# Staff Report

Infill Housing Design Review Committee

File Number: 10-A-21-IH

**Location:** 1547 Ohio Ave. **Parcel ID** 81 | S 011  
**Zoning:** RN-2 (Single-Family Residential Neighborhood)  
**District:** Lonsdale Infill Housing Overlay District

**PLOT PLAN FOR LOT 11,**

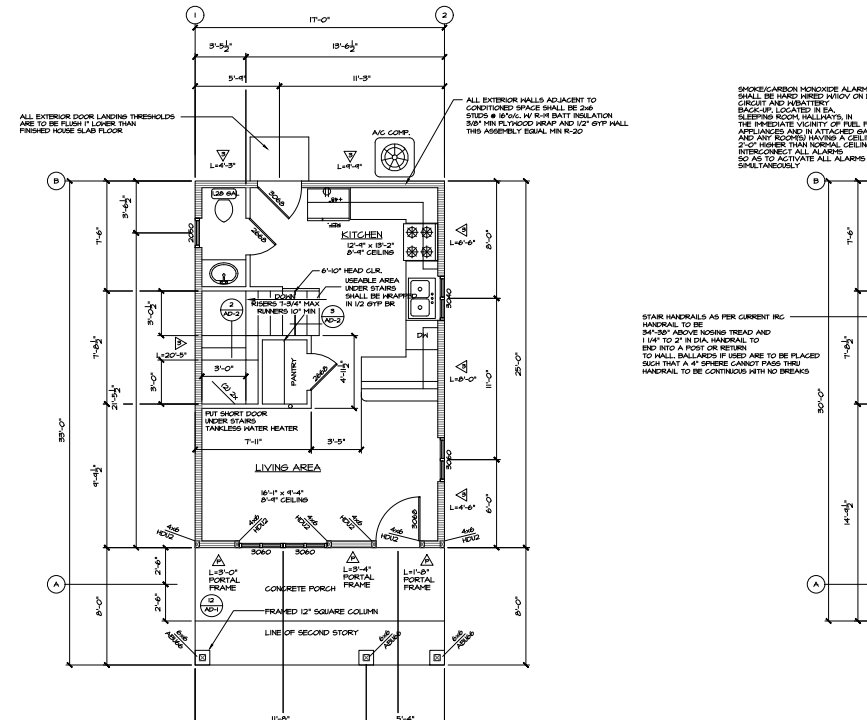
1. The submitted site plan does not specifically call out the front setback measurement; the 8' deep front porch looks to be approximately 26' from the front property line. There is only one other house at the end of the block, set approximately 27' from the front property line. Overall, the proposed front setback should be confirmed to meet the RN-2 dimensional standards and the broader context of the neighborhood.

3. The proposed parking meets the design guidelines by avoiding the front yard and placing the parking pad behind the house. The alley to the northeast of the site is not improved. Modifications to the site plan may be necessary to meet City Engineering standards, especially to address stormwater issue with a recently declassified stream on the site.

7. The 9/12 pitch, front-gable roof meets the design guidelines for slope; the shed roof on the porch incorporates additional roofline complexity.
8. The site plan incorporates trees in the front and rear yards.

Staff recommends postponement of Certificate 10-A-21-IH, so that a revised design can be submitted to the Board for further review, addressing items such as façade width, scale, porch proportions, and window placement, along with any stormwater issues which may exist on the site.

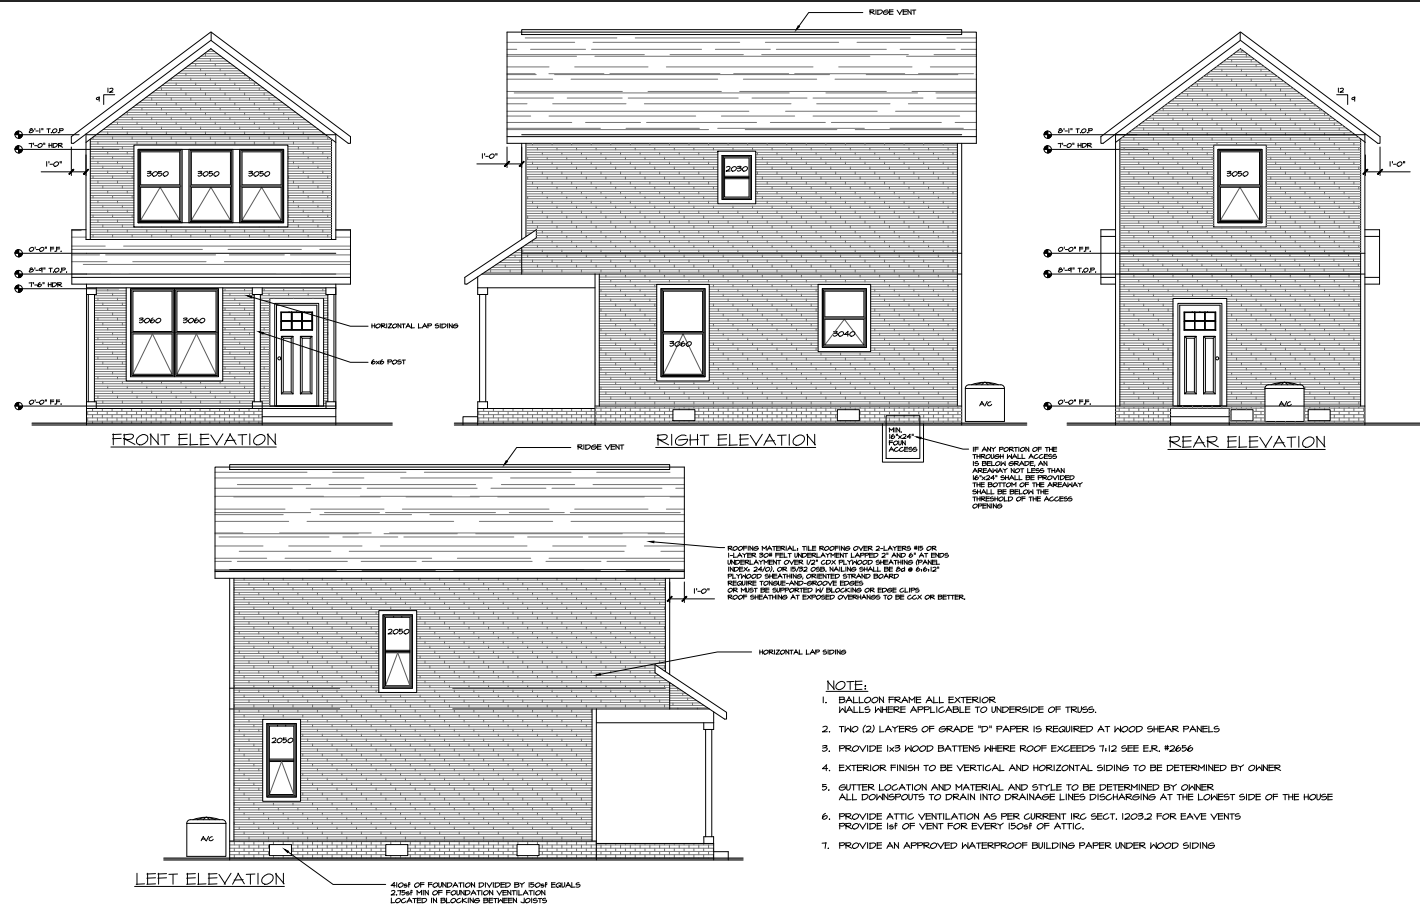
4. Guidelines note that "the front elevation should be designed to be similar in scale to the other houses on the street," and the "front façade of new houses should be about the same width as original houses on the block." The proposed house, at 17' wide and two stories tall, is not similar in scale or façade with nearby Craftsman bungalows or other Queen Anne cottages in the surrounding neighborhood. The foundation height is not clearly defined on the drawings.

5. The design includes an 8' deep front porch, partially recessed under a cantilevered interior space. The cantilevered section and porch roof do not reflect typical proportions from the context.

6. Guidelines state that "window and door styles should be similar to original or historic houses on the block," especially in "similar proportion and position" on the façade and paying attention to "window placement and ratio of solid to void." The proposed design includes six different window sizes and irregular placement. Window designs and proportions should be corrected to meet the design guidelines.
